Service Information

HR 8310
HR 8331

DAP156

Domestic Appliances and Personal Care

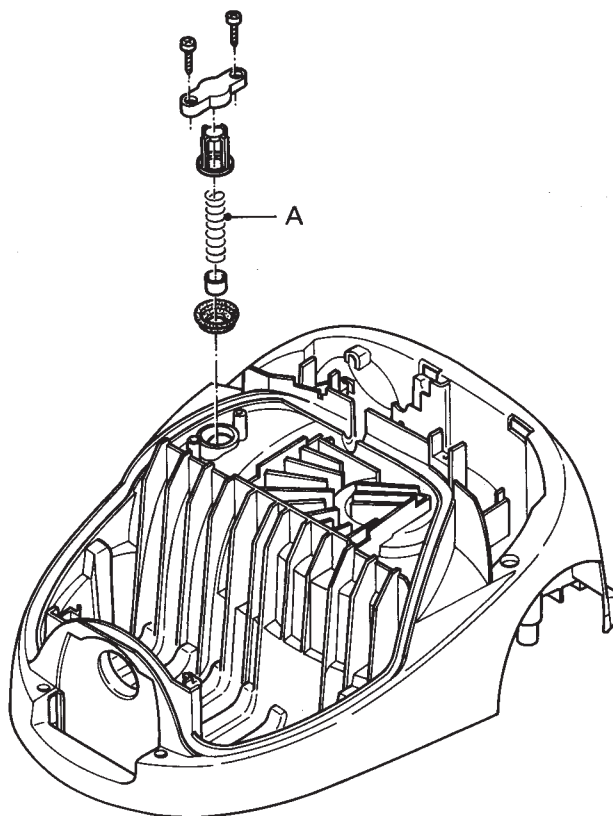
Item 16 (4822 441 11925, upper housing).

The item has been provided with a safety valve to prevent overheating of the motor if there is not enough air displacement or if the air displacement is hampered.

The spring (A) in upper housing 4822 441 11925 is only suitable for the **/A version** (see drawing).

The spares available (item 32 and 46) are only suitable for the /A version. The spares for the /B version are not available. The difference between the two versions is the motor connection plug. If item 32 is used for the /B version, the wire tree must be desoldered from the PCB and replaced with the wire tree of the original part (see drawing).

If this upper housing is used for the **/B version**, spring A must be replaced with spring 4822 492 11408.
